Agenda
Village of Arlington Heights
Design Commission
Community Room, 3rd Floor

Arlington Heights Village Hall
33 S. Arlington Heights Road
Arlington Heights, IL 60005
January 5, 2016
6:30 PM

STAFF DESIGN COMMISSION REPORT

Project Name: Schmelzer Residence
Project Address: 603 E. Euclid Ave.
Prepared By: Steve Hautzinger

Submitted Elevation

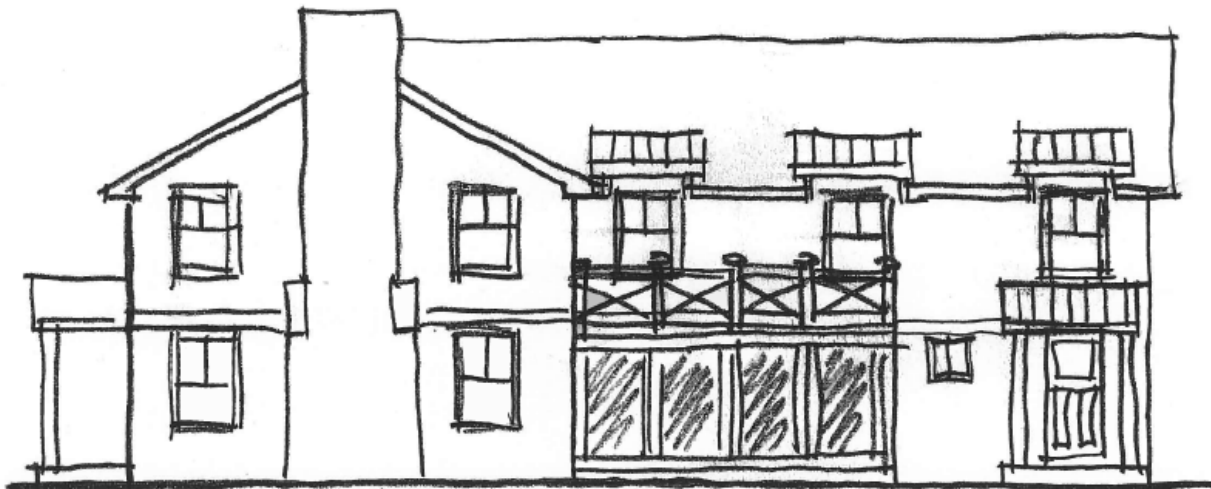
3. Exterior Side Elevation (facing Douglas Avenue):

- a. One of the goals of the Village's Single-Family Design Guidelines is that "...*New additions will look like they belong and not dominate or change the character of the original building*". The proposed addition on the rear of the house is large and dominates the existing home. Additions are always encouraged to be seamless with the existing house, and the proposed design clearly stands out as an addition.

- b. The composition of the addition is busy and awkward. A simpler rectangular form is recommended to complement the massing, scale, and composition of the original house.

- c. The large gable on the second floor is out of scale with the rest of the house and is recommended to be omitted.
- d. The second floor windows on the addition are higher than the second floor windows on the existing house. It is recommended that the windows in the addition be horizontally aligned with the existing house for a cohesive appearance.

The sketch below illustrates possible revisions to the design that address the concerns stated above.

1. The large second floor gable has been omitted to create a simple rectangular addition.
2. The second floor windows are horizontally aligned with the windows in the existing house.
3. The screen porch roof is changed to a flat roof with decorative railing for a traditional look that will complement the neighborhood.
4. The side entry portico has been simplified.
